Serial No.: 10/773,142

Title: WEATHER STRIP

SUPPLEMENTAL PETITION TO WITHDRAW ABANDONMENT

AMENDMENT UNDER 37 CFR 1.111

FIG. 26 111 112 112a XXVII -117 114a[′] 117 114

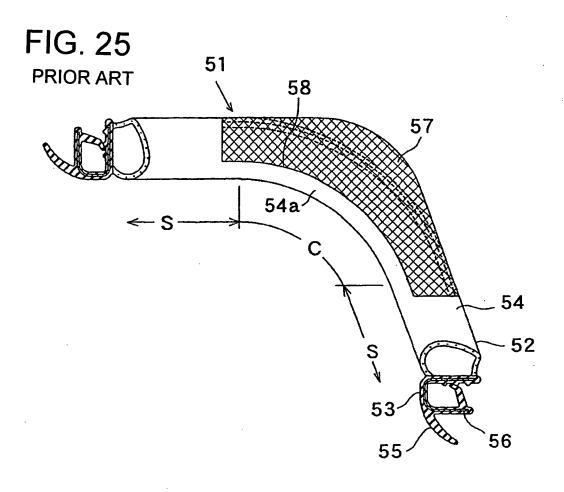
The phrase "a cutoff part being made on said hollow sealing portion" was said to render the claims indefinite. This phrase has been removed. Instead, claim 34 now recites an opening in the wall of the hollow sealing portion. The opening of claim 34 is shown in the exemplary embodiment of Fig. 26.
